CONSTRUCTION SUMMARY

2185715 Ontario Inc.

LOT NUMBER	PHASE	HOUSE TYPE	CLOSING DATE
024	1	ISABELLA-STD MAIN-4 BEDROOM-ELEVATION C

PURCHASE AGREEMENT FORM

KITCHEN - PLAN

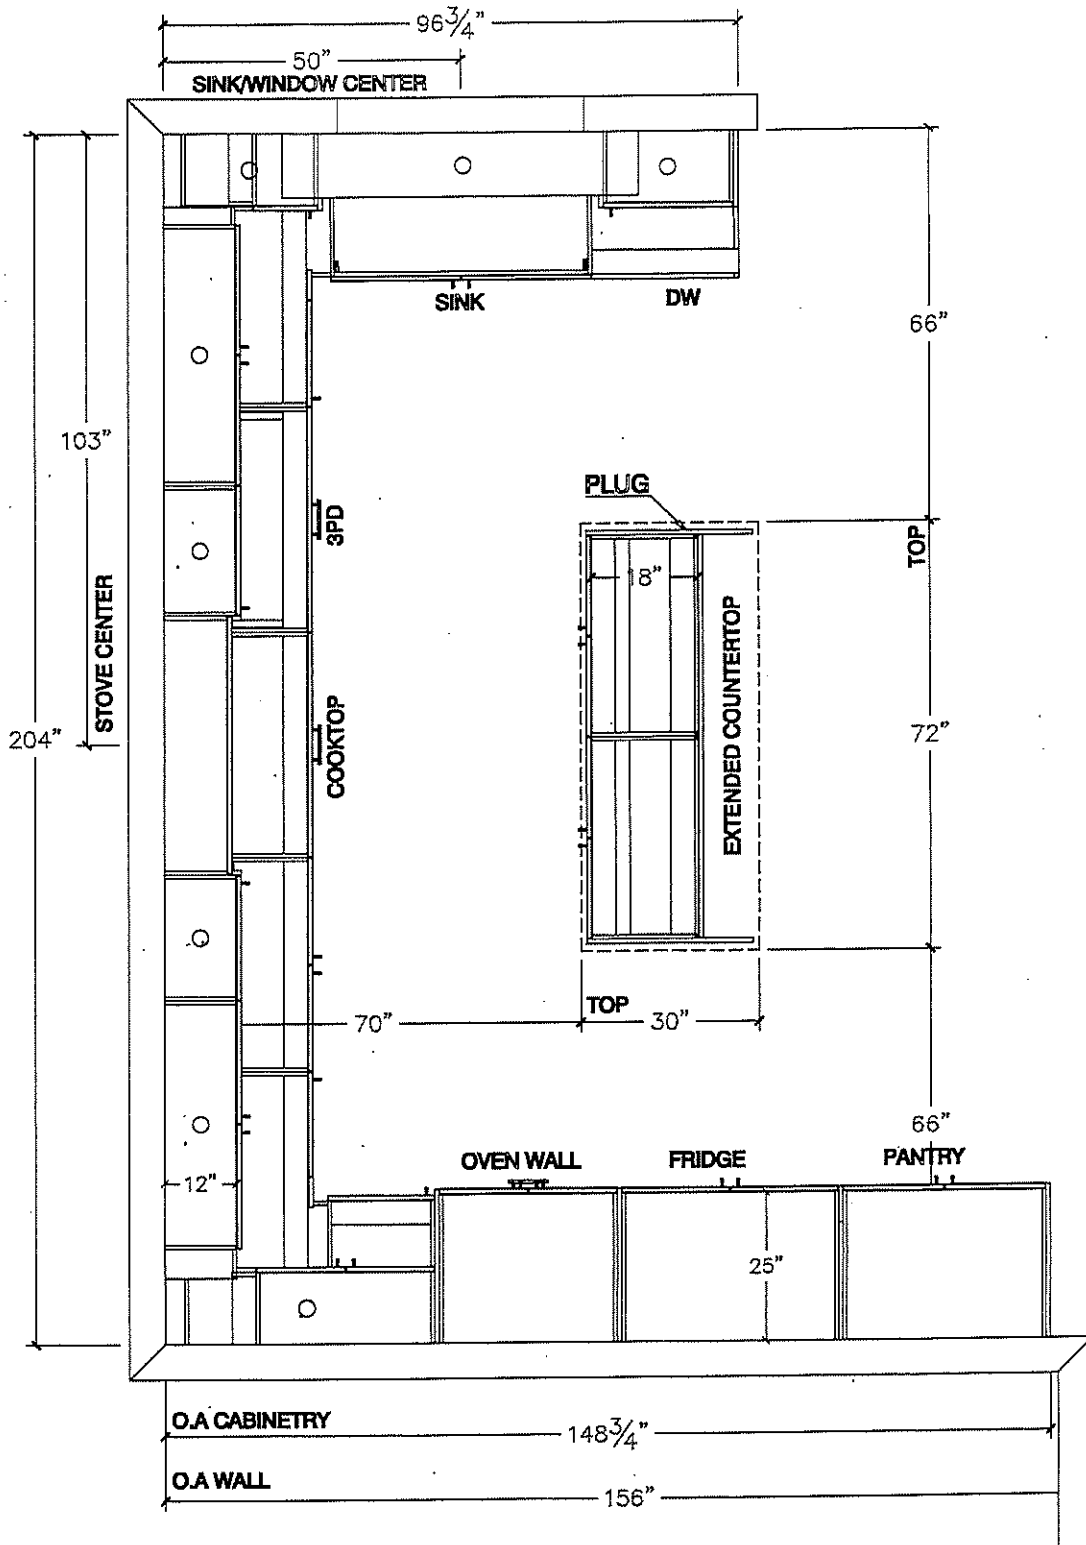
1 - KITCHEN- Install additional Emmerstone MAPLE WHITE counter top as per the revised kitchen layout (See QTK sketch attached)

MASTER ENSUITE (4 BED) - PLAN

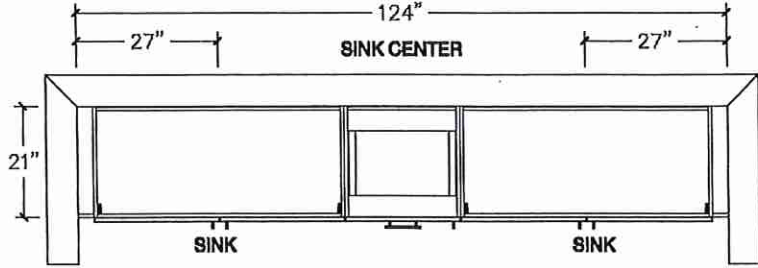
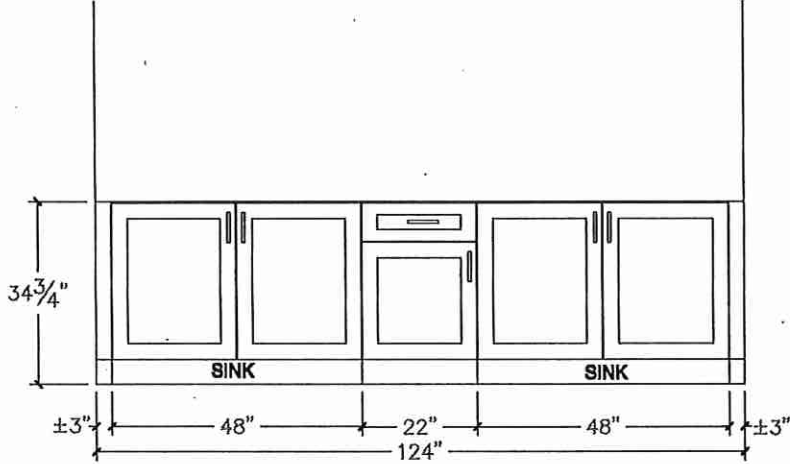
ITEM #	QTY	DESCRIPTION	PRICE
CUST-1	1	RAISE THE VANITY TO 34-3-4" - PER VANITY	
CUST-3	1	CATEGORY 1 DOOR STYLE AND FINISH: QTF 1201 WHITE (FIBERBOARD)	
CUST-4	1	CATEGORY 1 HARDWARE: DH00010	
ROOM SUMMARY:

RAISED VANITY.
